**From:** Turchy, Michael A  
**Sent:** Monday, July 7, 2025 10:05 AM  
**To:** Annino, Amy; Jamison, John  
**Cc:** Amschler, Crystal C CIV USARMY CESAW (US); McHenry, David G; Wojski, Paul A; Pjetraj, Michael; Bukowy (HNTB), Kat A  
**Subject:** RE: Request for Additional Information: DWR 20250109 V3 - Hurricane Helene I-40 Pigeon River Gorge Emergency Relief Project

**Subject:** Request for Additional Information: DWR 20250109 V3 - Hurricane Helene I-40 Pigeon River Gorge Emergency Relief Project

# TIP PROJECT: I-40 PIGEON RIVER

**S-006R3: REVISED PERMIT DRAWINGS**  
**DATE: 06/03/2025**

6/3/2025 c:\pw\working\rkk\production\dms\3276\I-40\_Pigeon\_River-Hydr-prm-psn.19.dgn

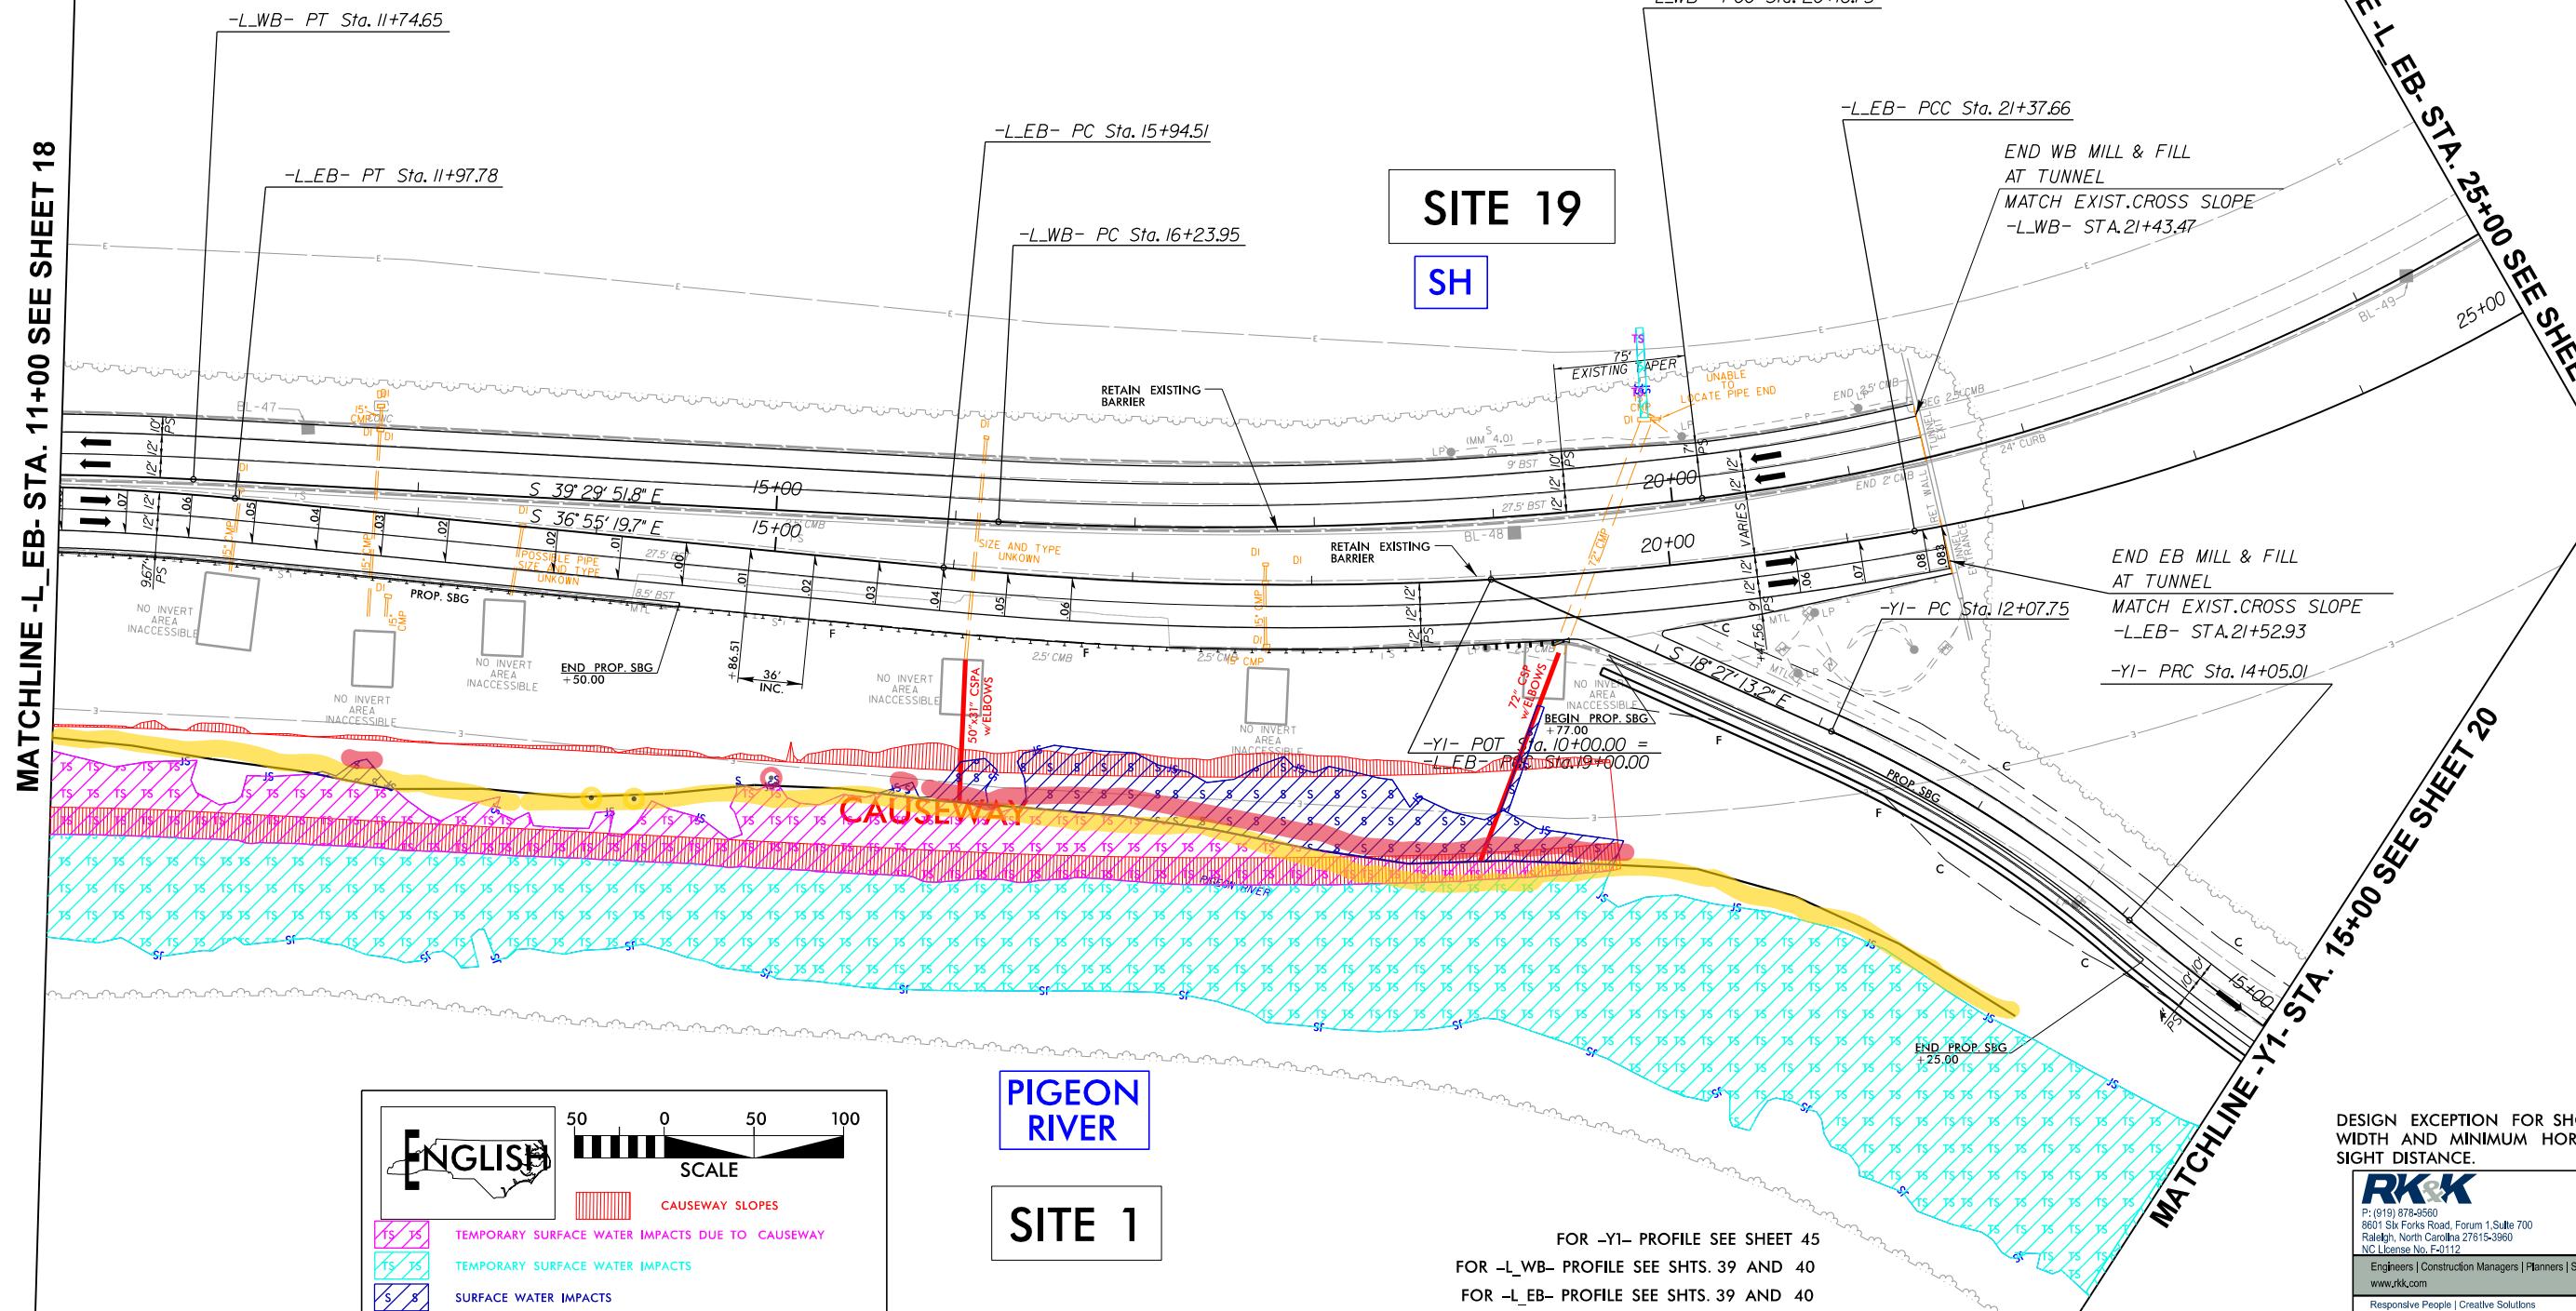
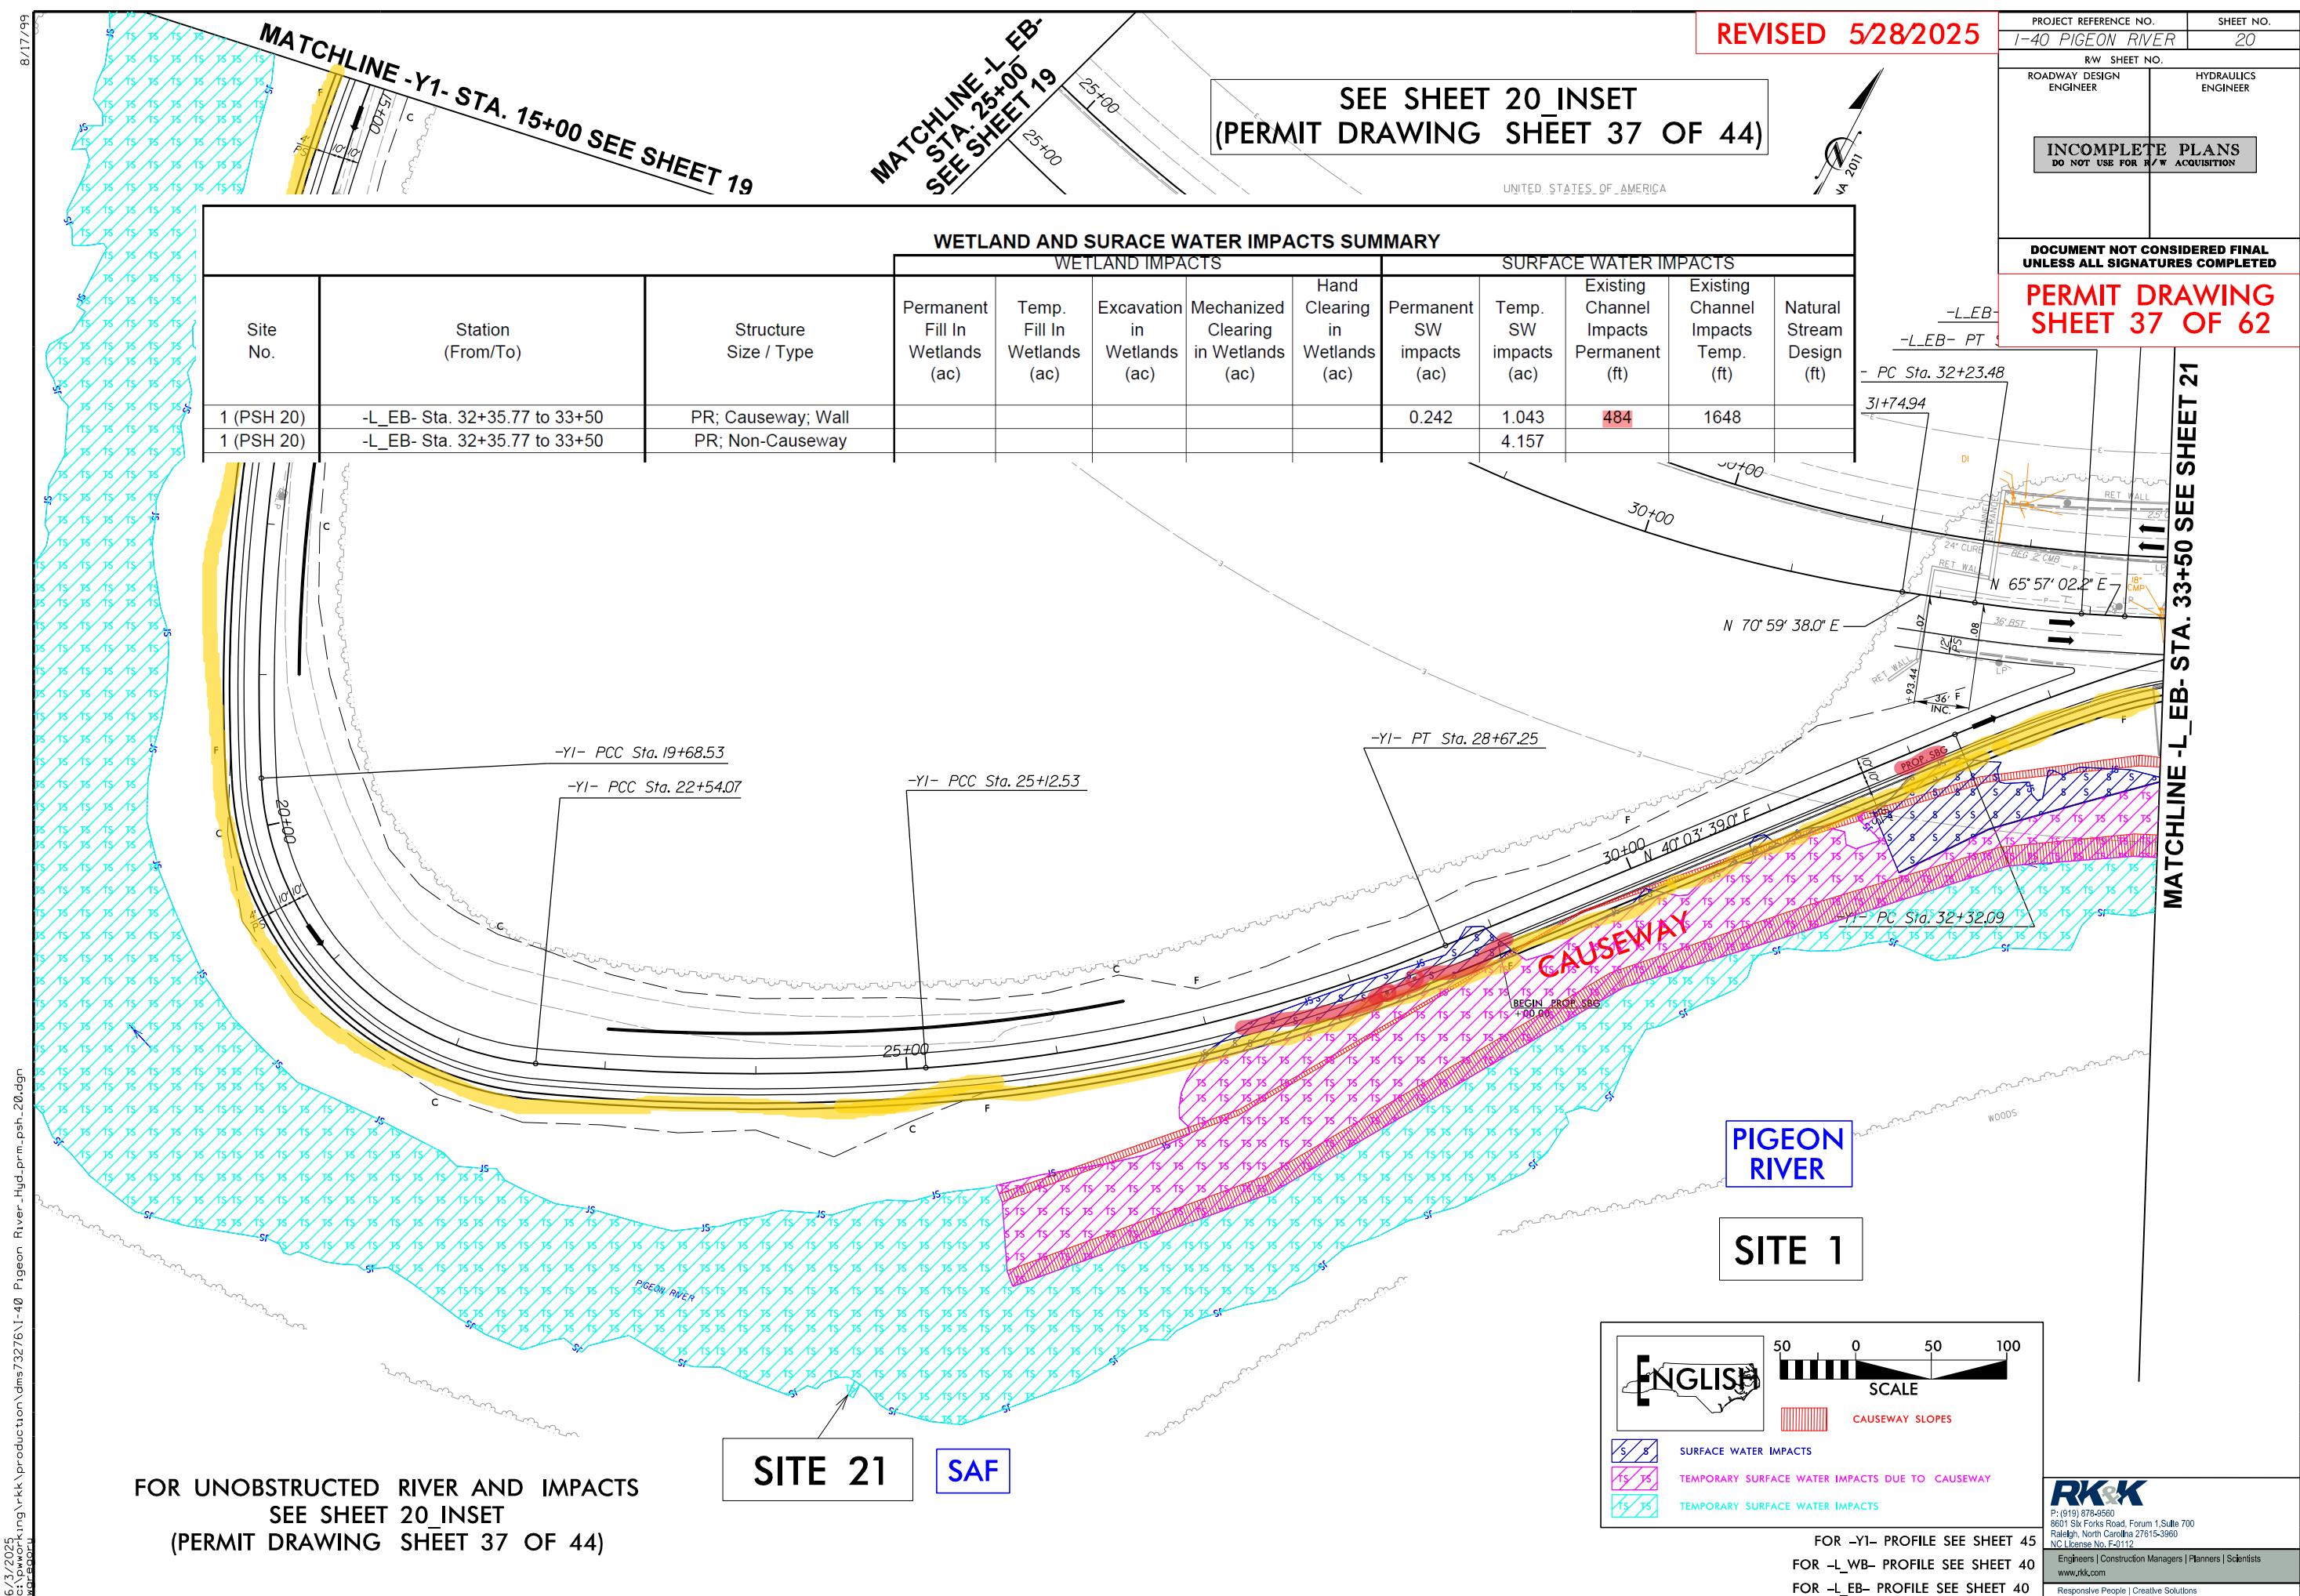
3. Please show the footprint of the proposed retaining wall through the project area

The proposed wall is located on the submitted set of drawings, and attached is a marked up set of drawings highlighting the wall for clarity, titled “**Drawings with Wall Highlighted**.”

The wall is highlighted in yellow. Wall impacts are highlighted in red.

Additionally, the impact summary table has been excerpted on each page to clarify the quantify the wall impact.

As previously noted, impacts are shown using the “scour zone limits” of the Pigeon River, as locating the ordinary high water mark post-Helene is not possible. Therefore, these drawings display a “worst case scenario” and are likely much lower than indicated.

The total proposed wall impacts to the Pigeon River are 12,116 linear feet.
